Access Compliance Report

Public Rights-of-Way

Intersection ID: 29270	Main Street: CHALK_HILL_LN	Cross Street: SPARROW_VALLEY_WY	Location: NW
ADA ID: 269BE8424EDC	Ramp Type: BlendTrans1	Initial Pass/Fail: Fail	Overall Compliance: No
			Severity Score: 21.25

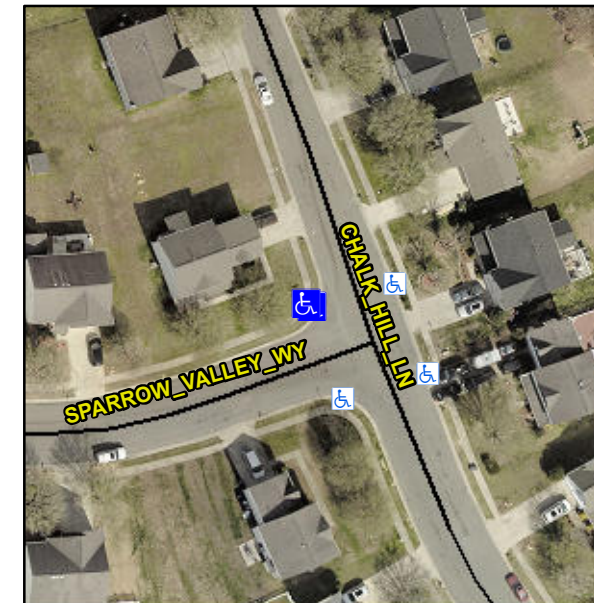
Not Found, R304.5.1, R304.5.3

Compliance	Description	Data	Compliance	Description	Data
N/A	Ramp Length (in)	52.0	Yes	BlendTrans Slope (%)	2.3
No	Ramp Width (in)	47.5	No	BlendTrans XSlope (%)	5.1
N/A	Flare Type LT	N/A	N/A	Flare Type RT	N/A
N/A	Flare Slope LT (%)	N/A	N/A	Flare Slope RT (%)	N/A
N/A	Flare Traversable LT?	N/A	N/A	Flare Traversable RT?	N/A
N/A	Landing Length (in)	N/A	N/A	DWS Provided?	N/A
N/A	Landing Width (in)	N/A	N/A	DWS Contrast?	N/A
N/A	Landing Slope (%)	N/A	N/A	DWS Length (in)	N/A
N/A	Landing X Slope (%)	N/A	N/A	DWS Full Width?	N/A
N/A	Landing Curb? (Y/N)	N/A	N/A	DWS Offset (in)	N/A
N/A	Shared Landing?	N/A			
N/A	Gutter Ponding?	N/A	N/A	Gutter Slope (%)	N/A
N/A	Gutter Lip Ht (in)	N/A	N/A	Gutter X Slope (%)	N/A
N/A	Painted X Walk1?	No	N/A	Painted X Walk2?	No
	X Walk 1 Direction	To SE		X Walk 2 Direction	To NE
	X Walk 1 Width (in)	N/A		X Walk 2 Width (in)	N/A
	X Walk 1 Slope (%)	0.8		X Walk 2 Slope (%)	2.5
	X Walk 1 X Slope (%)	5.8		X Walk 2 X Slope (%)	0.5

Remove & Replace Curb Ramp With Two New Directional Ramps or Equivalent.
